Proposal for amendments to false reaction avoidance of UN Regulation 152

I. Proposal

Figure 1: LEFT TURN OR RIGHT TURN AT THE INTERSECTION

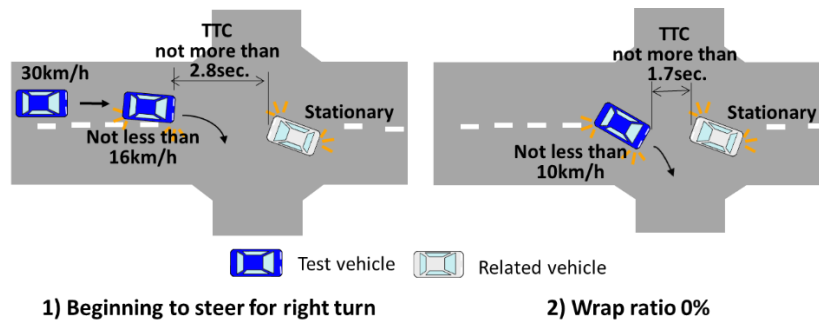
Scenario 1: Left turn or Right turn at the intersection

1.1. In this scenario, the subject vehicle passes by a left turn or right turn in front of an oncoming vehicle that is stopped to make a left turn or right turn at an intersection.

The subject vehicle drives at a speed of 30 km/h (with a tolerance of +0/-2 km/h) toward the intersection, and decelerates by braking to a speed of not less than 16 km/h at a point where the subject vehicle begins to steer left / right, and the TTC to the oncoming vehicle is not more than 2.8 seconds. When the subject vehicle turns left or right in the intersection, the speed is reduced to not less than 10 km/h, and then drives at a constant speed. The TTC to the oncoming vehicle is not more than 1.7 seconds at when the wrap ratio between the subject vehicle and the oncoming vehicle becomes 0%.

Figure 2: RIGHT TURN OR LEFT TURN OF A FORWARD VEHICLE

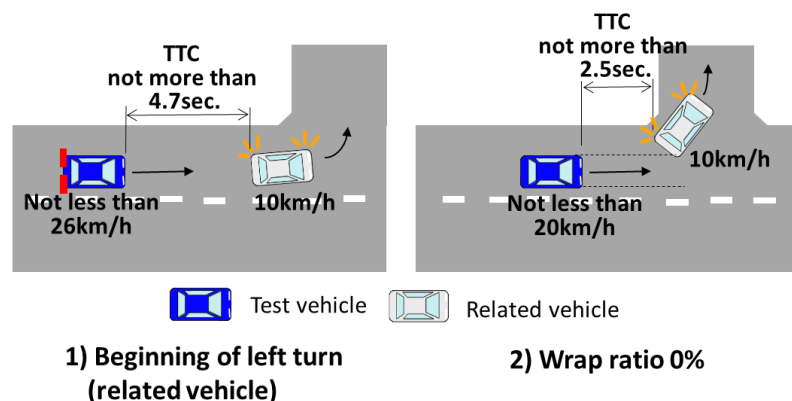
Scenario 2: Right turn or Left turn of a forward vehicle

- 2.1. In this scenario, the subject vehicle follows a forward vehicle. After that, the forward vehicle turns right or left at a corner, and the subject vehicle goes straight.
- 2.2. An example of the detail scenario:

Both the forward vehicle and the subject vehicle drive at a speed of 40 km/h (with a tolerance of ± 2 km/h) on the straight road. The forward vehicle decelerates by braking to a speed of 10 km/h (with a tolerance of ± 2 km/h) in order to turn right or left at the corner, and the subject vehicle also decelerates by braking to keep appropriate distance with the forward vehicle. At when the forward vehicle begins to turn right or left, the speed of the subject vehicle is not less than 26 km/h and the TTC to the frontal vehicle is not more than 4.7 seconds. After that, the subject vehicle decelerates to a speed of not less than 20 km/h, and then drives at a constant speed. The TTC to the forward vehicle is not more than 2.5 seconds at when the wrap ratio between the subject vehicle and the forward vehicle becomes 0%.

Figure 3: CURVED ROAD WITH GUARD PIPES AND A STATIONARY OBJECT

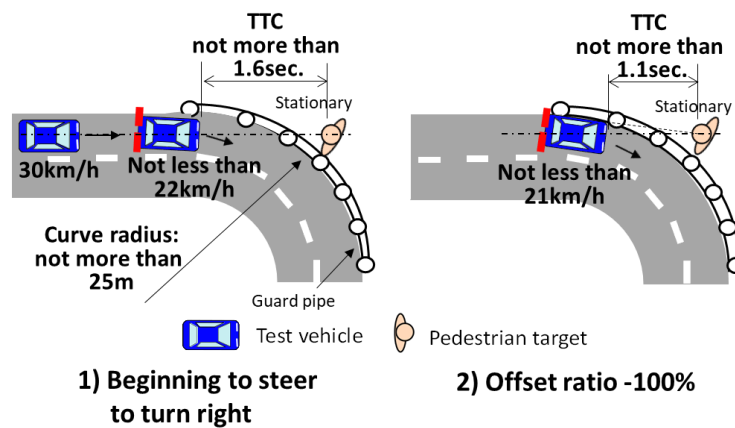
Scenario 3: Curved road with guard pipes and a stationary object

- 3.1. In this scenario, the subject vehicle drives a small radius curved road of which the guard pipes are constructed to the outer side, and a stationary vehicle (M1 category), a stationary pedestrian target or a stationary bicycle target is positioned just outside of the guard pipes and where on the extension of the centre of the lane.
- 3.2. An example of the detail scenario:

The subject vehicle drives at a speed of 30 (with a tolerance of +0/-2 km/h) km/h toward the curve of which the radius is not more than 25 m at the outer side of the road, and decelerates by braking to a speed of not less than 22 km/h at a point where the subject vehicle enters the curve. The TTC to the stationary object is not more than 1.6 seconds at when the subject vehicle begins to turn in the curve. In the curve, the subject vehicle drives outer lane than the centre of the road. After that, the subject vehicle continue to turn in the curve at a constant speed of not less than 21 km/h. The TTC to the stationary object is not more than 1.1 second at when the wrap ratio between the subject vehicle and the stationary vehicle becomes 0%, or at when the offset ratio* between the subject vehicle and the centre of the stationary pedestrian target or the stationary bicycle target becomes -100%.

Figure 4: LANE CHANGE DUE TO ROAD CONSTRUCTION

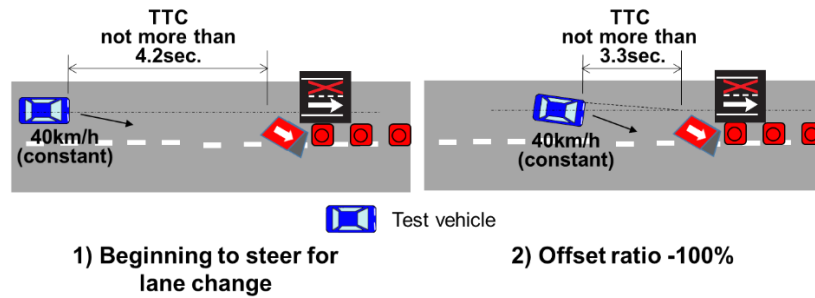
Scenario 4: Lane change due to road construction

- 4.1. In this scenario, the subject vehicle changes the lane in front of the signboard which is positioned in the centre of the lane and notifies the driver that the lane is reduced.
- 4.2. An example of the detail scenario:

The subject vehicle drives a straight road at a speed of 40 km/h (with a tolerance of +0/-2 km/h), and begins to steer in order to change the lane in front of the signboard which notifies reducing the lane. No other vehicles approach the subject vehicle. The TTC to the signboard is not more than 4.2 seconds at when the subject vehicle begins to steer. During changing the lane, the speed of the subject vehicle is constant, and the TTC to the signboard is not more than 3.3 seconds at when the

offset ratio between the subject vehicle and the centre of the signboard becomes -100%.
